**Re: Third Notice of Violation
Fairfield Union HS / Fairfield County**

This letter is written in follow-up to a construction storm water inspection that I conducted at the Fairfield Union High School and the road-widening project along State Route 22. This site is located at 6401 Cincinnati-Zanesville Road near Rushville, Ohio and the inspection was conducted on April 7, 2010. The purpose of the inspection was to evaluate compliance with the General Storm Water Permit Associated with Construction Activities. Please consider this the third formal notice of violation with your permit. During the inspection, the following items were noted:

Fairfield Union School
Stabilize barren areas
Rush Creek Watershed
April 7, 2010
Photo by: Greg Sanders

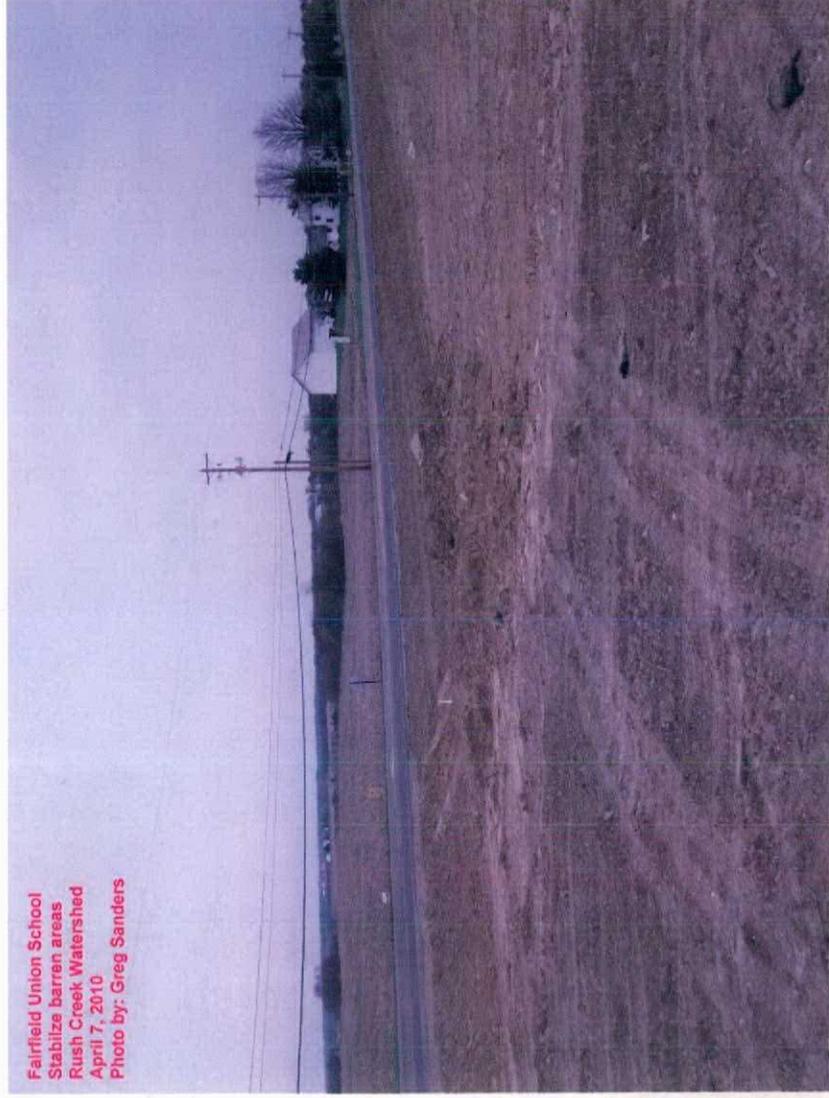
Barren Areas: 21 Day Rule:

- Be aware the General Permit states that all barren areas which remain idle in excess of 21 days must be protected from erosion within seven days of the last earth disturbing activities. In addition, erosion protection must be implemented for all areas of final grade within seven (7) days. This regulation directly applies to the areas along Cincinnati-Zanesville Road in front of the old school, as well as an area at the entrance of the new school. Several areas have been barren for several months. Please see attached pictures.
- There was a lot of fugitive dust on the pavement around the old school building near the construction trailer. This fugitive dust must be removed and future fugitive dust prevented.
